Return To Library > Records 2 > ERID-105000 Through ERID-105499 > ERID-105038 1) SUBMITTAL OF THE RESPONSE TO THE NOTICE OF DISAPPROVAL FOR THE INVESTIGATION WORK PLAN FOR UPPER CANADA DEL BUEY AGGREGATE AREA AND REVISION 1, 2) NOTICE OF DISAPPROVAL EPA ID NO NM0890010515, HWB-LANL-08-013, LA-UR-08-6121, EP2008-0507, 3) INVESTIGATION WORK PLAN FOR UPPER CANADA DEL BUEY AGGREGATE AREA, REVISION 1, LA-UR-08-6122, EP2008-0508, 4) MAP PLATE 1, 5) ATTACHED CD LA-UR-08-6122, EP2008-0508

Date: September 29, 2008
Refer To: EP2008-0507

Subject: Submittal of the Response to the Notice of Disapproval for the Investigation Work Plan for Upper Cañada del Buey Aggregate Area and Revision 1

Figure 5.1-2 Proposed sampling locations for SWMUs 46-002, 46-003(b), and 46-009(b)

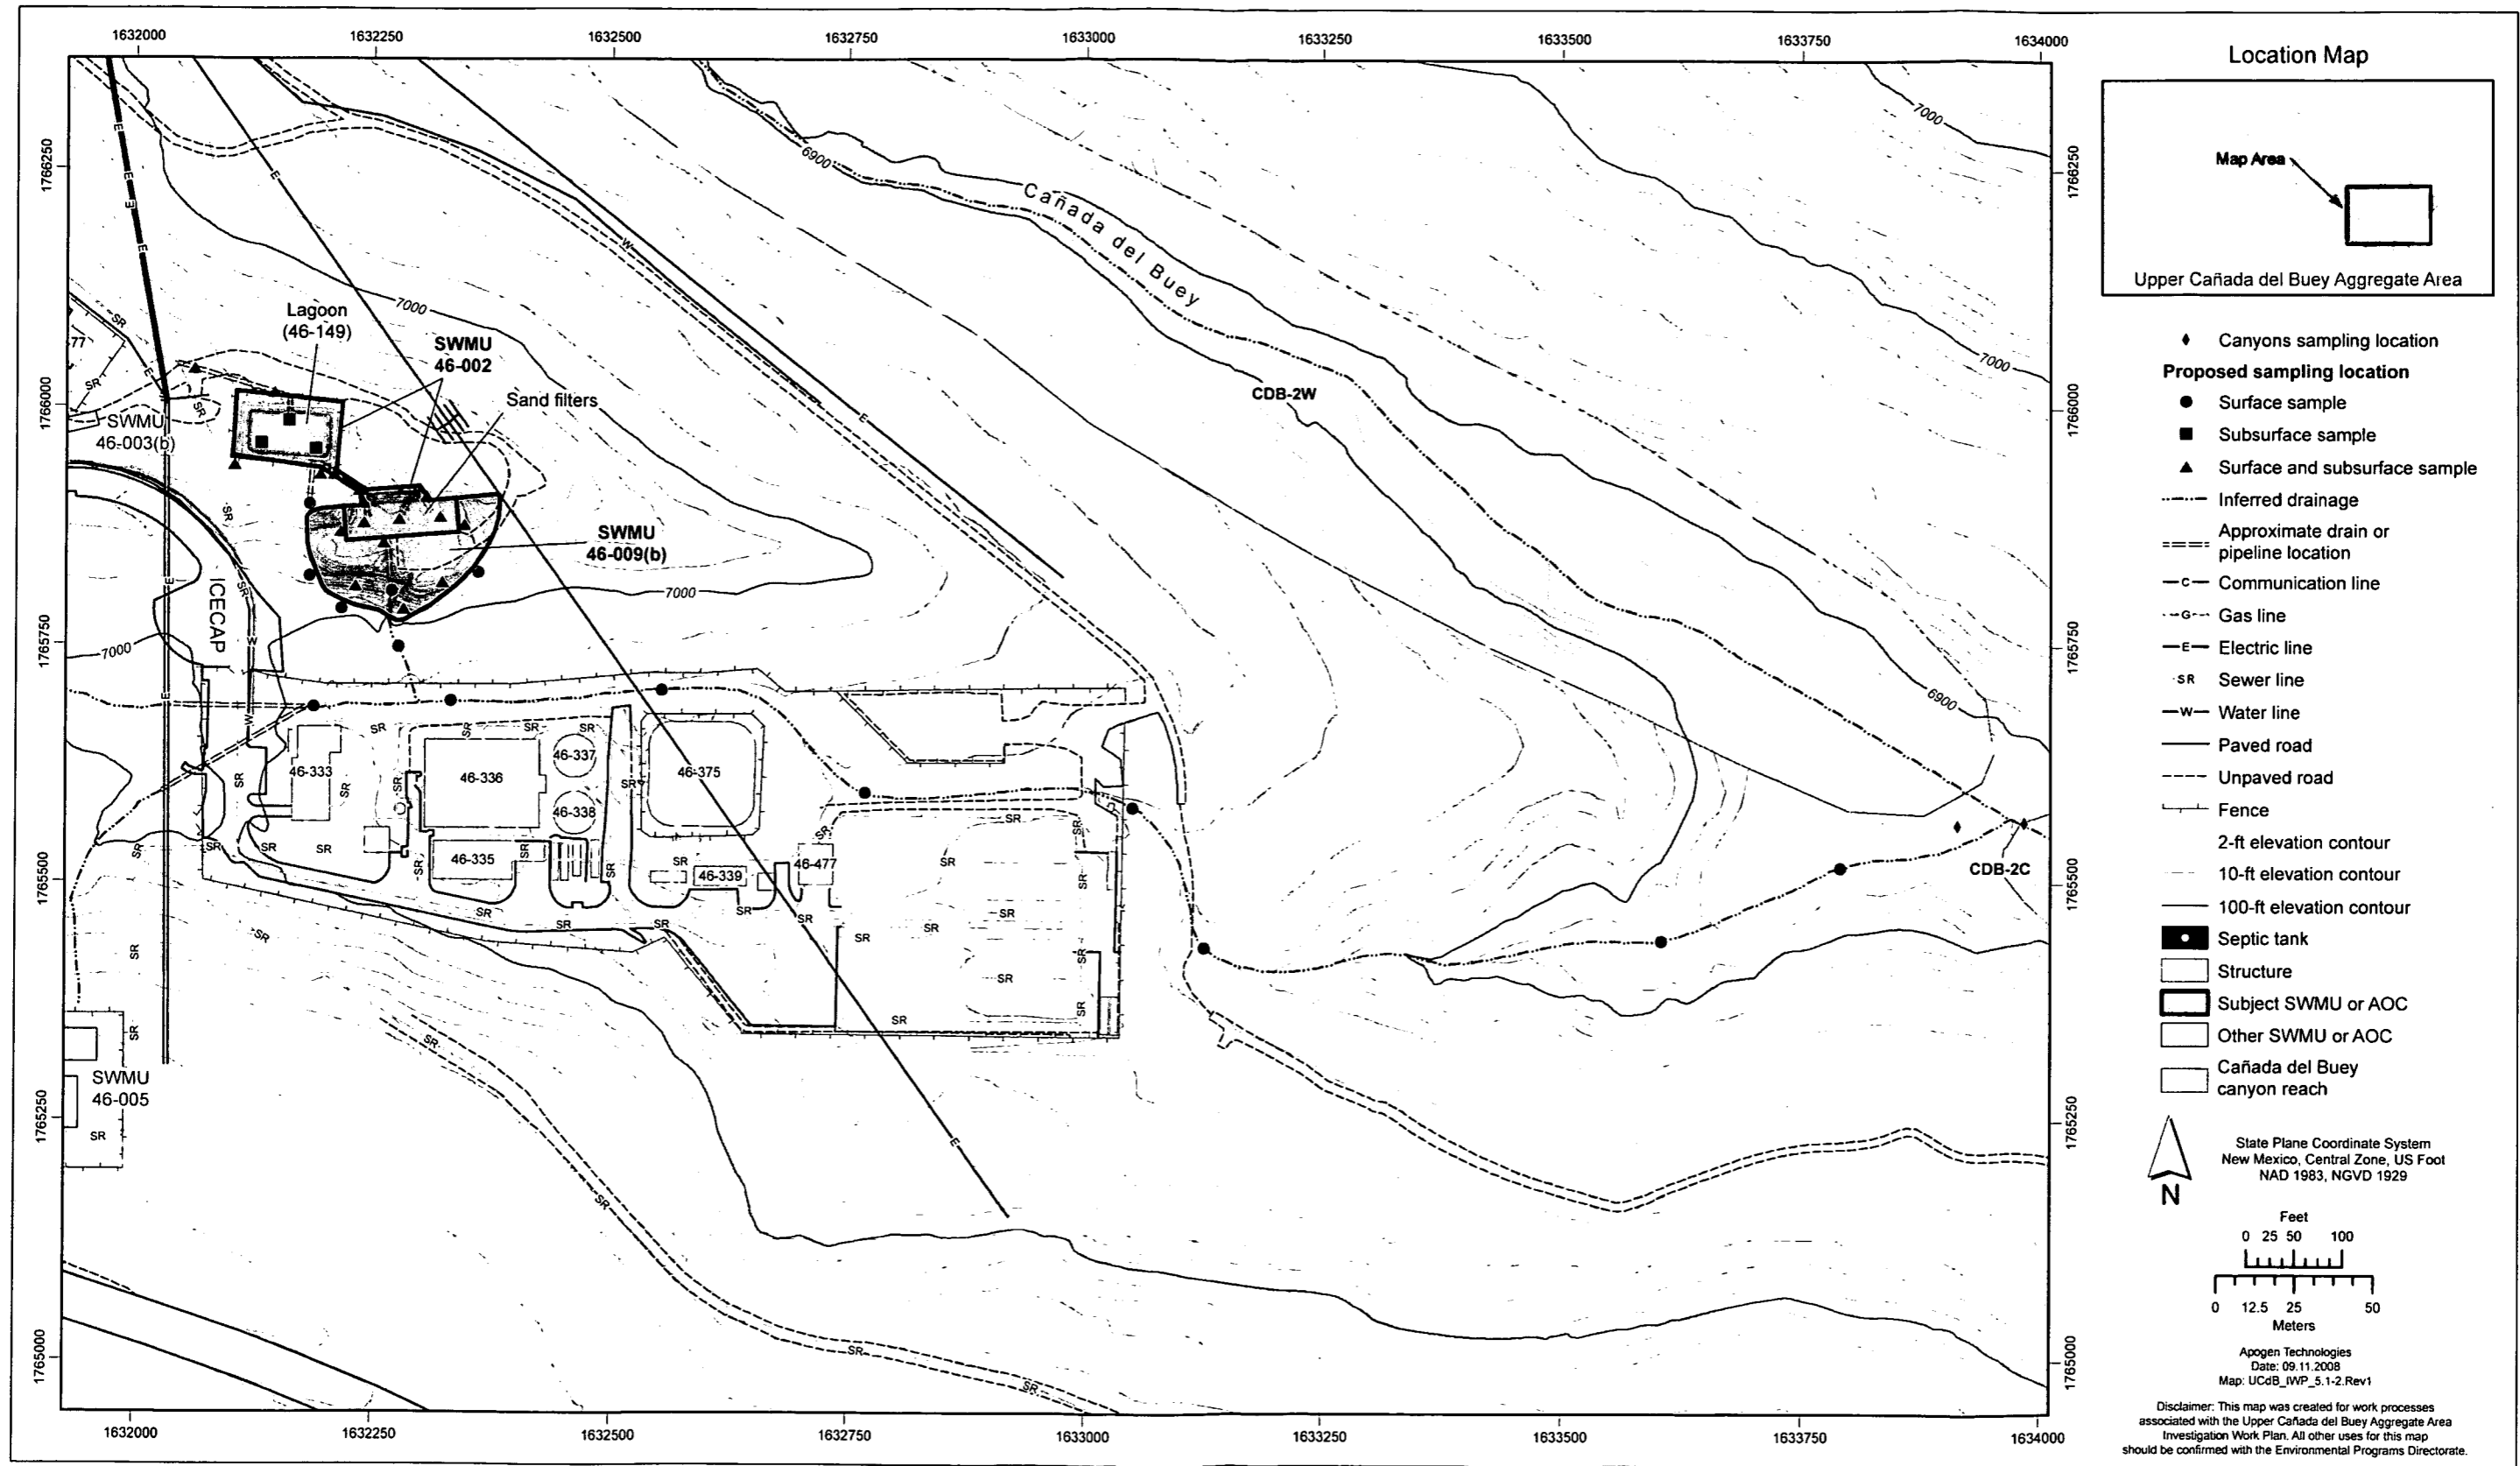
Permittees' Statement: "Six samples will be collected from three mesa slope next to and downgradient of the former surface disposal area (Figure 5.1-2)."

NMED Comment: *In addition to the three mesa slope locations shown on Figure 5.1-2 of the Plan, sample locations must be proposed in the eastward drainage located just south of the southernmost mesa slope location. The Permittees must ensure that samples are collected in the drainage to Cañada del Buey Canyon to define the nature and extent of contamination. See also, comment 12 above.*

13. Figure 5.1-2 and the text in section 5.47.2 have been revised to include 14 samples from seven additional locations in the drainage south and east of SWMU 46-009(b) in SWSC Canyon to define the nature and extent of contamination. Table 4.0-1 has been revised to indicate samples will be collected from two depth intervals at each of the new sampling locations and analyzed for the same constituents proposed for other locations at SWMU 46-009(b).

Figure 5.4-2 Proposed sampling locations for SWMUs 46-003(c), 46-003(f), 46-004(f), 46-004(r), 46-004(t), 46-004(w), 46-008(a), 46-008(d), and 46-008(g)

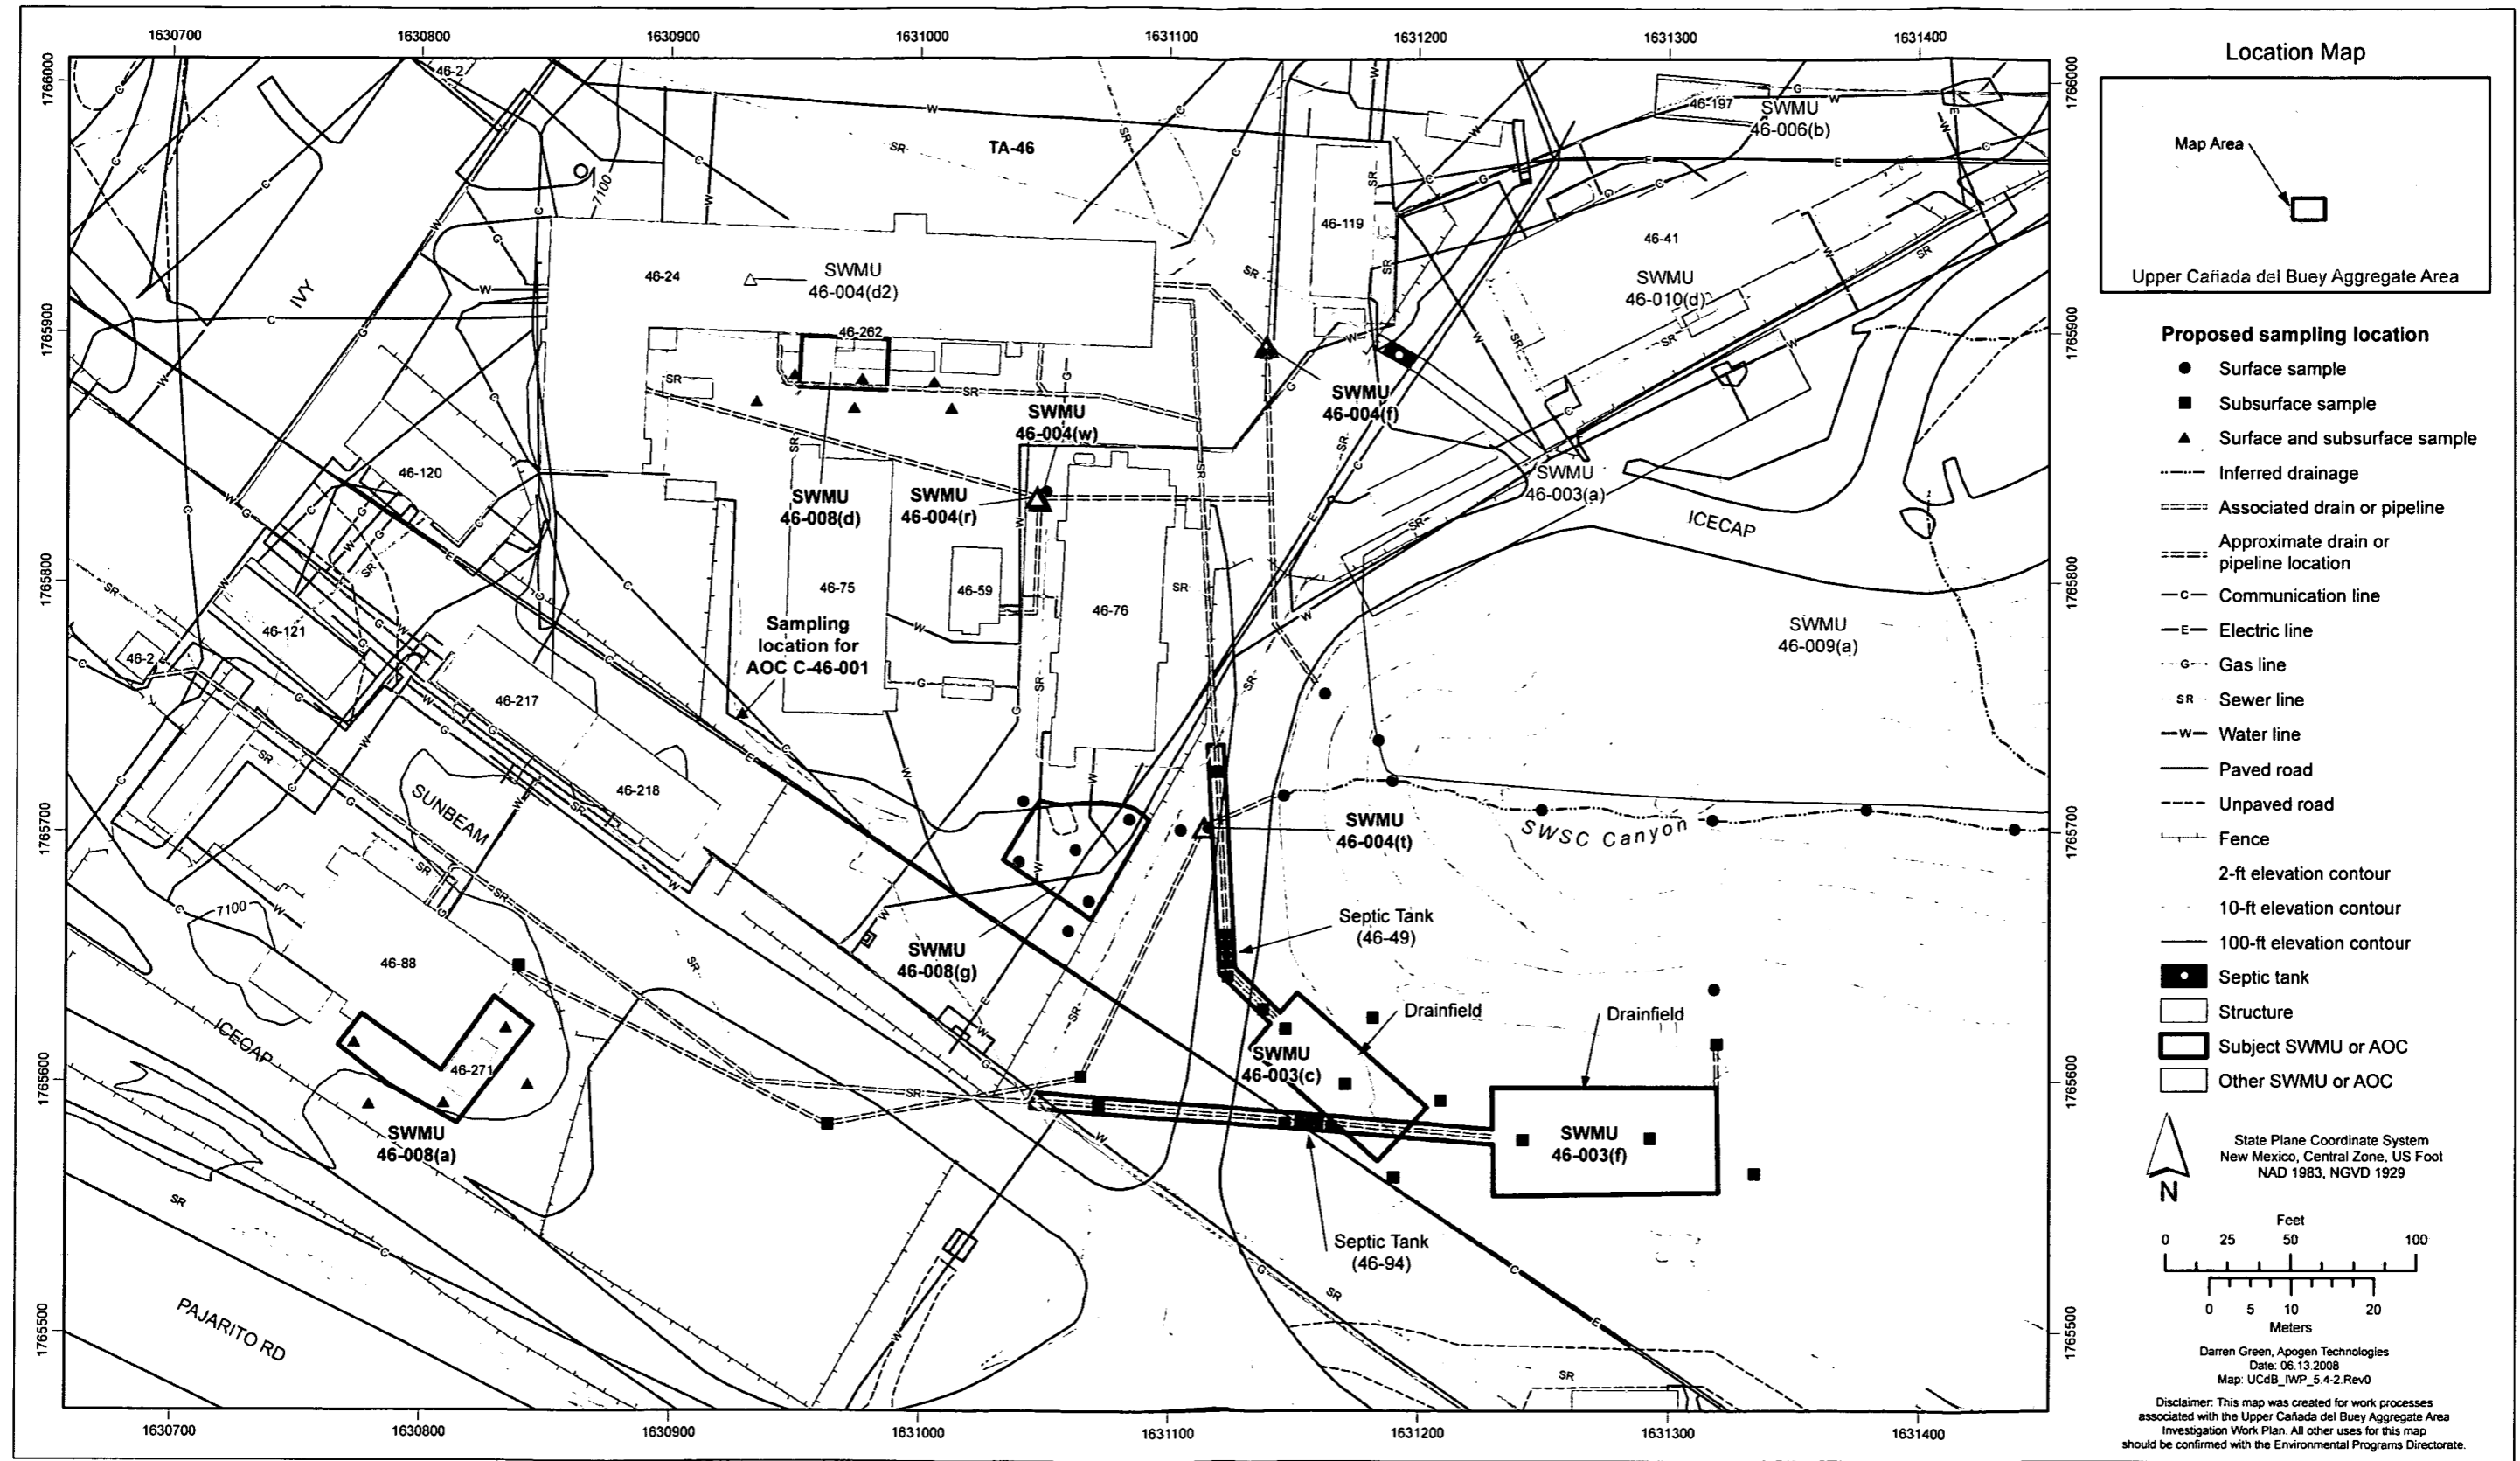
Permittees' Statement: "Eight samples will be collected from four locations associated with the distribution box and drain field to define nature and extent of contamination (Figure 5.4-2)."

NMED Comment: Figure 5.4-2 shows a pipeline structure exiting the northeast corner of the site drain field. The Permittees have proposed a sample location at the north end of the structure. The Plan must be revised to clarify the nature and use of the structure. If the structure is an outfall associated with the drain field, the Permittees must propose additional down slope sampling locations north of the structure to characterize the area between the structure and the common drainage segment of SWSC Canyon.

NMED Comment: *Given the uncertainty of where the spill occurred and the drainage patterns of the paved areas around Building 46-75, a multi-depth sample location is needed above the storm drain approximately 25 feet southwest of the southwest corner of the building shown on Figure 5.4-2 of the Plan.*

Figure 5.4-2 has been revised to show the additional sampling location and the sampling locations in SWSC Canyon downgradient of SWMU 46-003(f).

15. Figure 5.4-2 and the text in section 5.49.23 have been revised to indicate that two samples will be collected from one additional sampling location above the storm drain, approximately 15 ft southwest of the southwest corner of building 46-75. Table 4.0-1 has been revised to indicate that the samples will be collected from two depth intervals (0 to 1 ft and 2 to 3 ft beneath the asphalt) and analyzed only for mercury.
